REMARKS/ARGUMENTS

Amendments to the Drawings:

The enclosed Submission of Formal Drawings includes changes to Figs. 14A-14E, 14H-14P, 15A, 16A, 16B, 16D, 16F, 17P-17CC (now Figs. 17O-17BB), 18B (now Fig. 18B-4), 18C, 18H, 19H, 33D and 64B.

Fig 14A

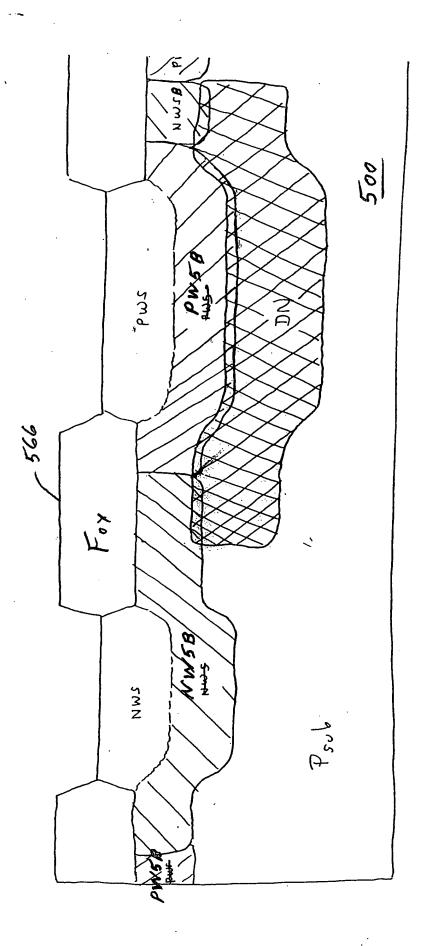
In Figs. 14A-14E, 14H-14P, 15A, 16A, 16B, 16D and 16F, in a number of instances the reference numeral PW5 has been changed to PW5B, the reference numeral NW5 has been changed to NW5B, the reference numeral PW12 has been changed to PW12B, and the reference numeral NW12 has been changed to NW12B, as shown on the enclosed Annotated Sheets. These changes are clearly supported, for example, at page 36, lines 14-17, of the substitute specification filed February 18, 2004, where it is indicated that the suffix "B" is used to denote an implanted layer of dopant as opposed to a "well" of dopant. In any event, these changes are merely changes in labeling and as such do not constitute new matter.

Fig. 188

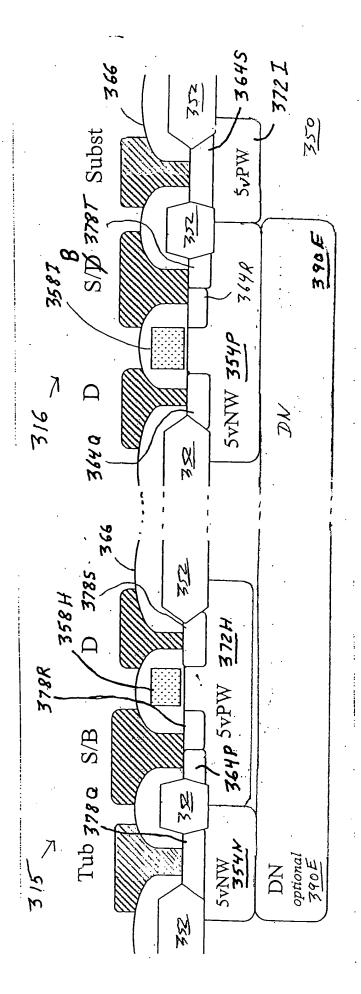
To make the drawings more legible, Figs. 18A and 18B have each been split into four drawings, designated Figs. 18A-1 to 18A-4 and Figs. 18B-1 to 18B-4, respectively. The subject matter in Figs. 18A-1 to 18A-4 and 18B-1 to 18B-3 is unchanged. In Fig. 18B-4, the reference numeral 354M has been replaced by the numeral 354L. The numeral 354M was an error. There is no such reference numeral in the application as filed.

F19 18C

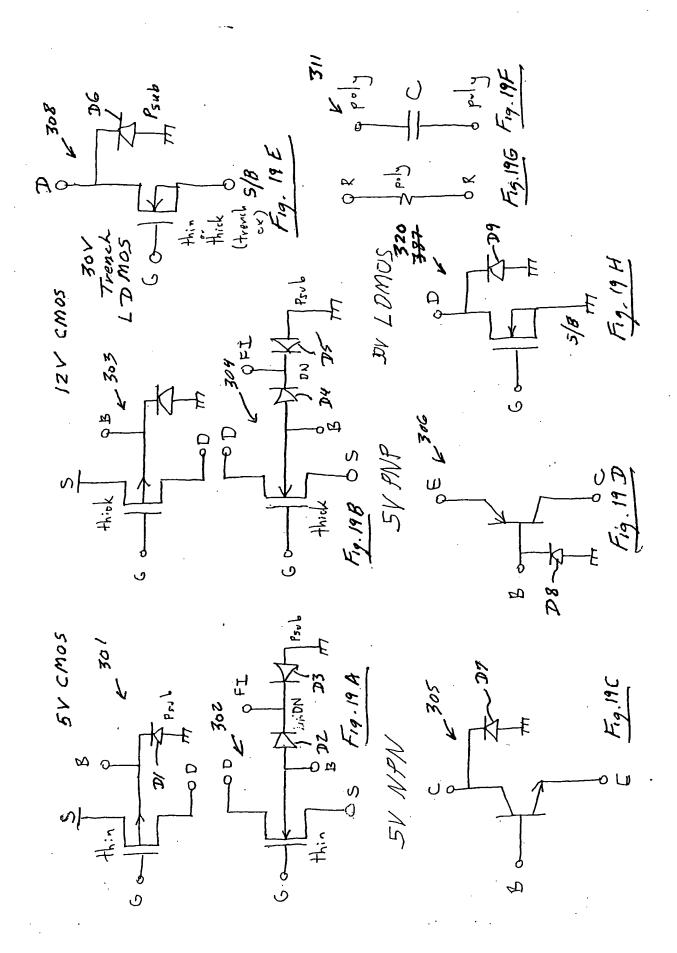
In Fig. 18C, the reference numeral 364P, which is referred to at page 66, line 4, of the substitute specification, has been added, and the designation of the source-body contact has been corrected from "S/D" to "S/B".

Fig. 18 H

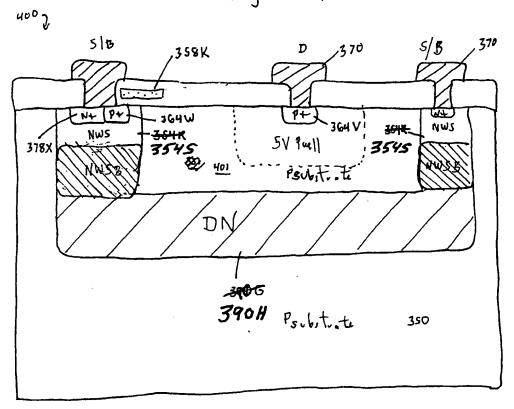
In Fig. 18H, reference numeral applicable to the well NW5 has been changed from 354R to 354S to eliminate the conflict with the similarly numbered element in Fig. 18G; and

the reference numeral applicable to the deep N layer has been changed from 390G to 390H to eliminate the conflict with the similarly numbered element in Fig. 35A.
